BEFORE THE STATE CORPORATION COMMISSION  
OF THE STATE OF KANSAS

In the Matter of the Capital Plan	)	
Compliance Docket for Kansas City	)	
Power & Light Company and Westar	)	Docket No. 19-KCPE-096-CPL
Energy, Inc. Pursuant to the	)	
Commission's Order in Docket No. 18-	)	
KCPE-095-MER	)

**COMMENTS OF THE COUNCIL FOR THE NEW ENERGY ECONOMICS  
REGARDING EVERGY'S 2023 ANNUAL UPDATE**

# **A Review of Evergy Kansas Central and Evergy Metro 2023 Annual IRP Update**

**Table 6. Estimated Cost of 1,215 MW Orange County CC**

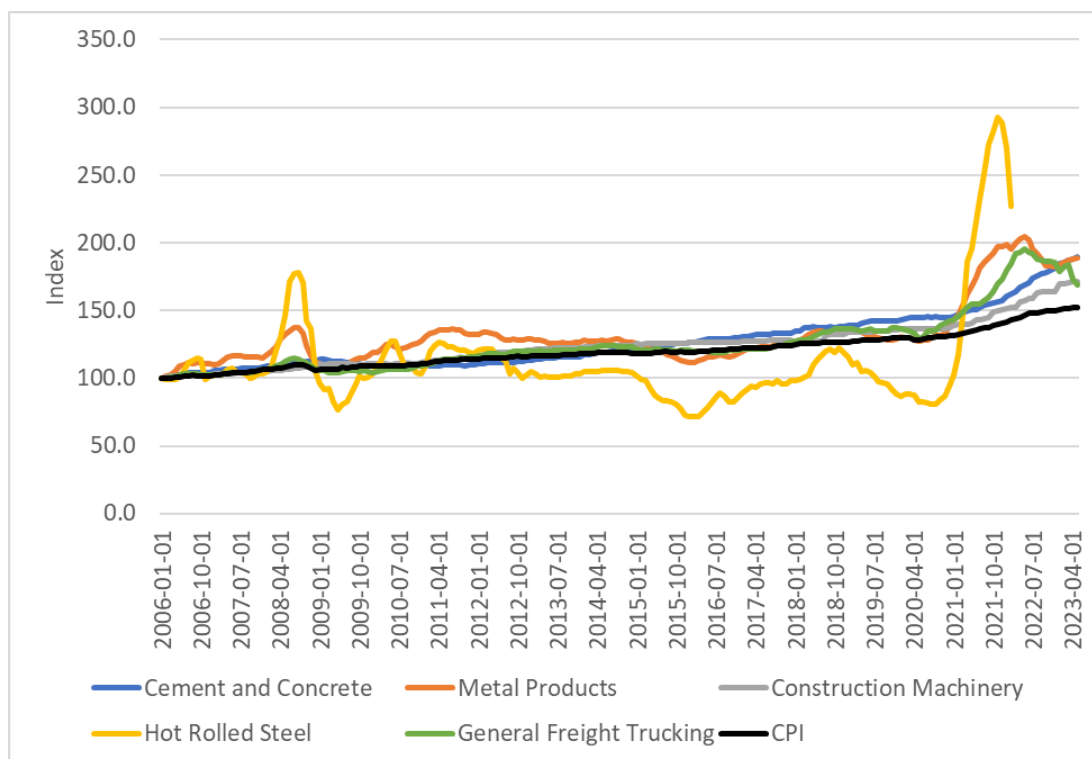
The cost of this facility is noteworthy for several reasons. First, it is among the first combined cycle facilities that have gone through more detailed cost estimating in the current inflationary environment. Second, the facility is 233% larger than the largest CC modeled by the Company but costs approximately \*\*\* [REDACTED] \*\*\* more. There are typically economies of scale associated with larger units and so it would be highly unusual for a much smaller CC to cost materially less than a much larger facility.

In addition, filings associated with the Orange County project show that inflation in key outputs have led to these cost increases and more cost is expected if the limited notice to proceed (“LNTTP”) to the Company’s engineer, procure, construct (“EPC”) contractor is delayed.<sup>20</sup> This is relevant to Evergy’s cost estimates because they are, of course, merely preliminary and not connected to any particular contract or facility.
